## NEW HIGH SCHOOL IN BUNGENDORE - APPLICATION NO. SSD-14394209

### Further Objection from Save Bungendore Park Inc. following Response to Submissions - General

**Location of  
proposed  
development**

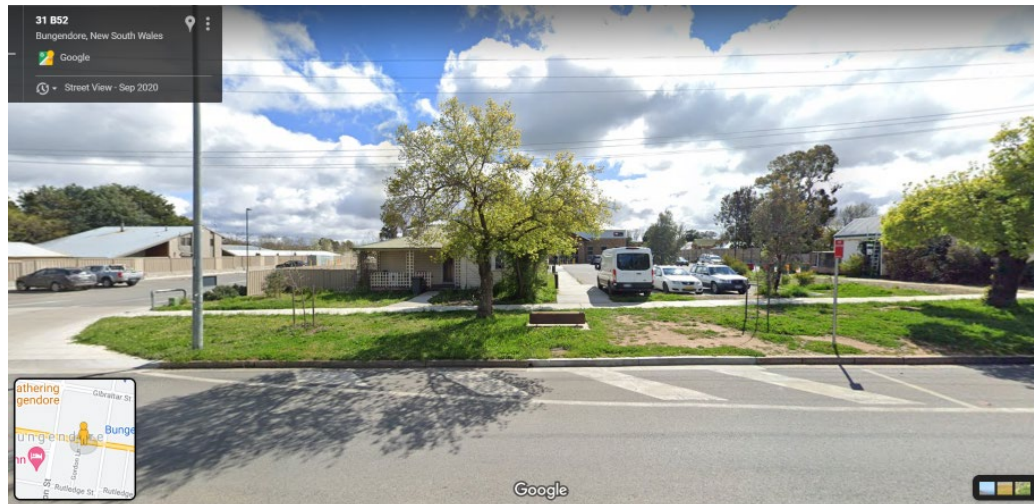
162.	Appendix 4 - 1.6 – Bulk and Scale	The GANSW recognised that the proposed development was inappropriate in bulk and scale for the town. The Applicant fails to address this. Instead, the Applicant states that the proposed development is “generally isolated from the town and neighbouring buildings”.	Objection maintained. Despite design changes, the development is of massive bulk and scale and inappropriate for the historic town centre.
		<p>This is absurd and inconsistent. The Applicant has made frequent public statements (including in the EIS and p33 of Appendix 4) highlighting the central location of the development. Indeed, in 5.1 (page 13) of Appendix 4, the Applicant notes that “the site is in a relatively central location to the town area and located on the eastern edge of the historic portion of the town.” Similarly, in 7.3.3 of the EIS, the Applicant states that “the site is situated in a relatively central location of Bungendore” with the surrounding area “generally characterised by low density residential uses, civic and public buildings, and recreational open space.” It is in fact in the absolute geographic centre of Bungendore, as shown below.</p> <p>The development will dominate the approach to the centre of Bungendore along McCusker Drive (a major thoroughfare from the Elmslea subdivision), where it will be directly in front of pedestrians and motorists who will approach from below, on a rising, right-hand bend.</p> <p>The scale is such that it is likely to dominate the view to Bungendore approaching the town from the east on the Kings Highway.</p>

The Applicant has chosen to use misleading perspectives of the Bungendore IGA Supermarket and Bungendore Scout Hall to suggest that the proposed development is consistent with the town's character. This is incorrect. In particular:
